**PLANNING AND ZONING COMMISSION
CITY OF BETTENDORF
AUGUST 19, 2020 AT 5:30 PM
CITY HALL COUNCIL CHAMBERS
1609 STATE STREET**

Staff Report

Case No. 20-045 (Rezoning) and Case 20-047 (Final Plat)

Case 20-046 (Replat) and Case 20-050 (Site Development Plan)

LANDSCAPE PLAN

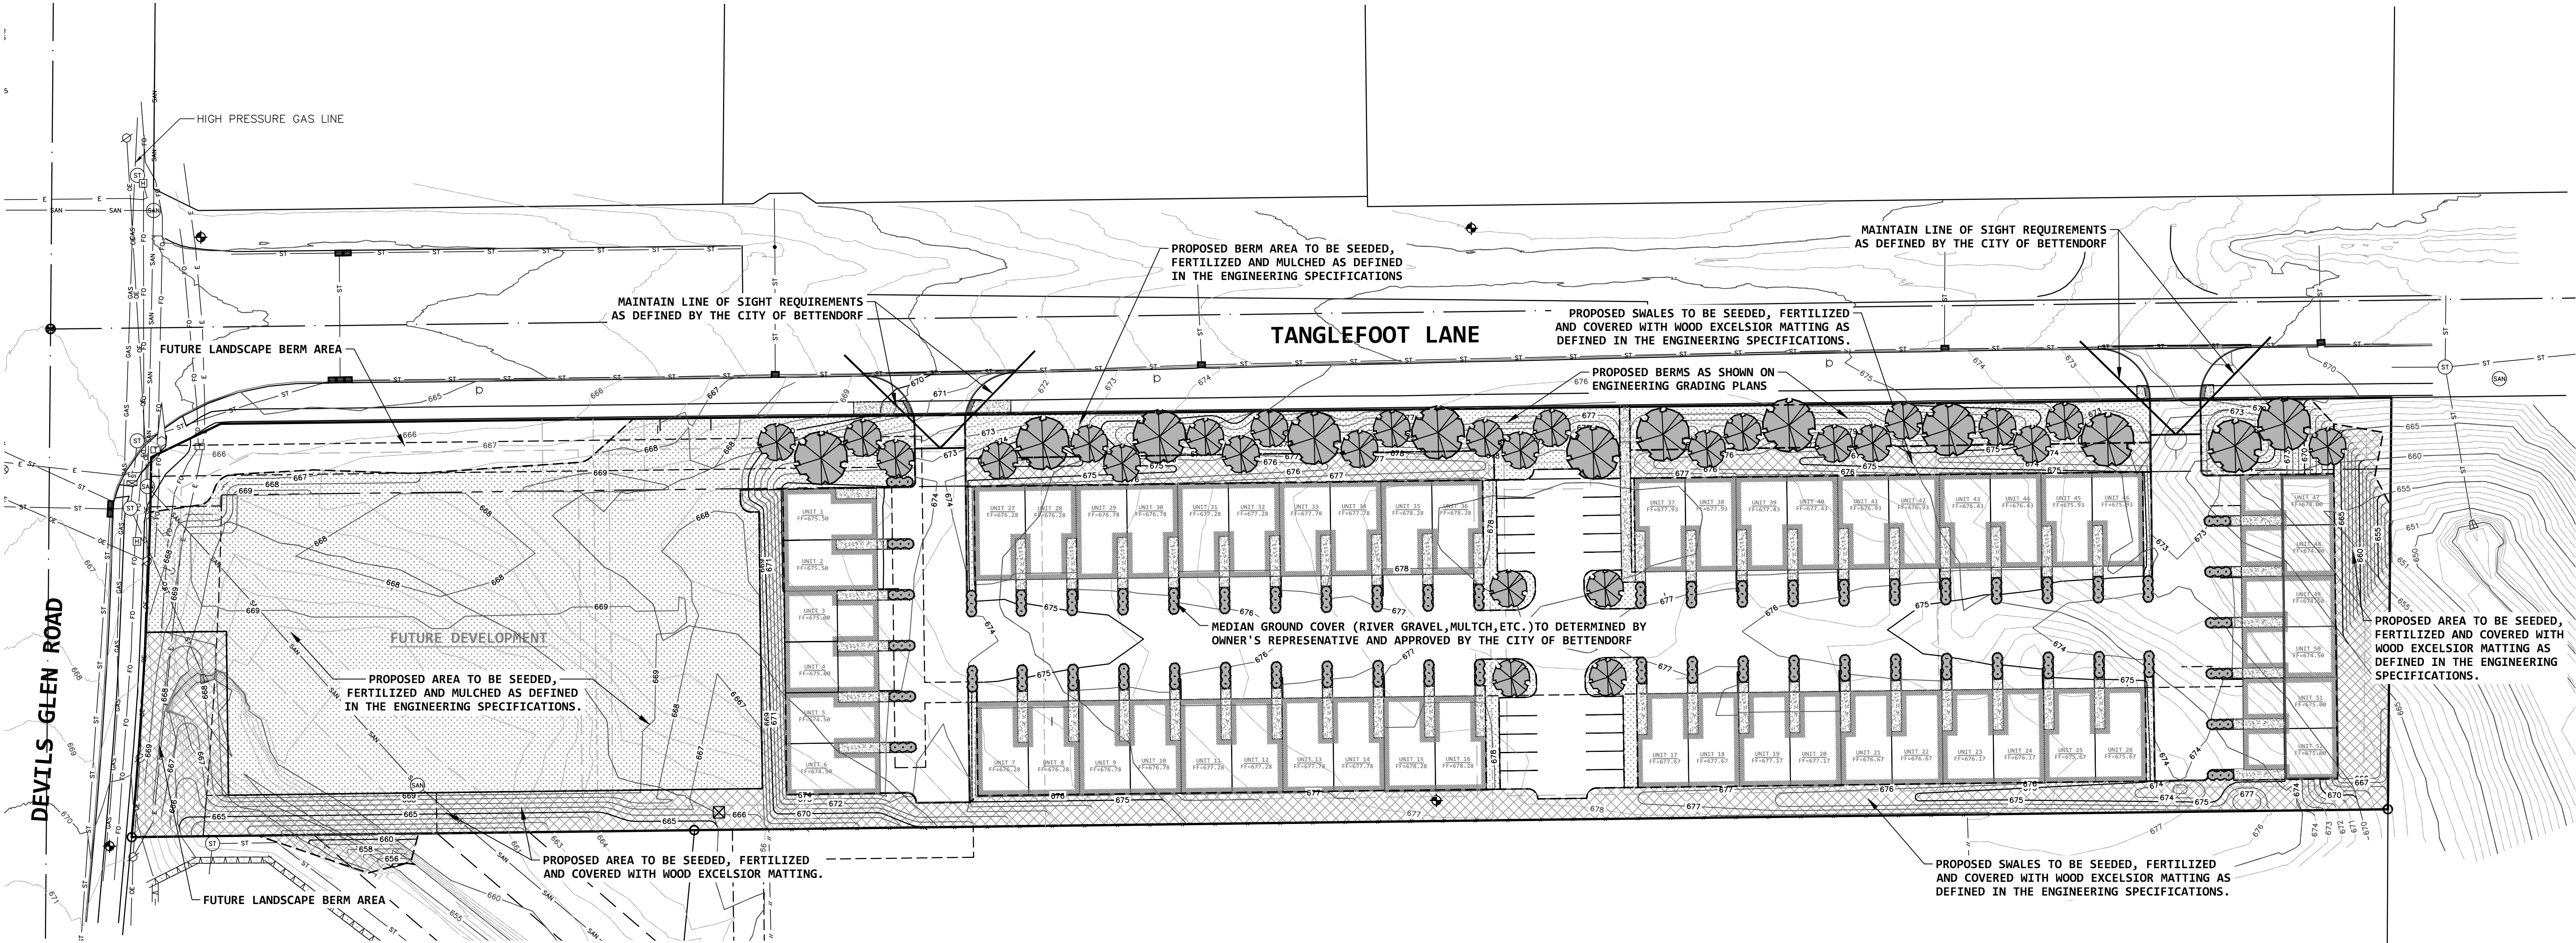
6. Tree count for streetscape requires 40 trees; only 23.5 tree credits are shown.
7. All Fire Department requirements for internal turning radii and drive widths shall be met prior to City Council consideration of this site development plan.
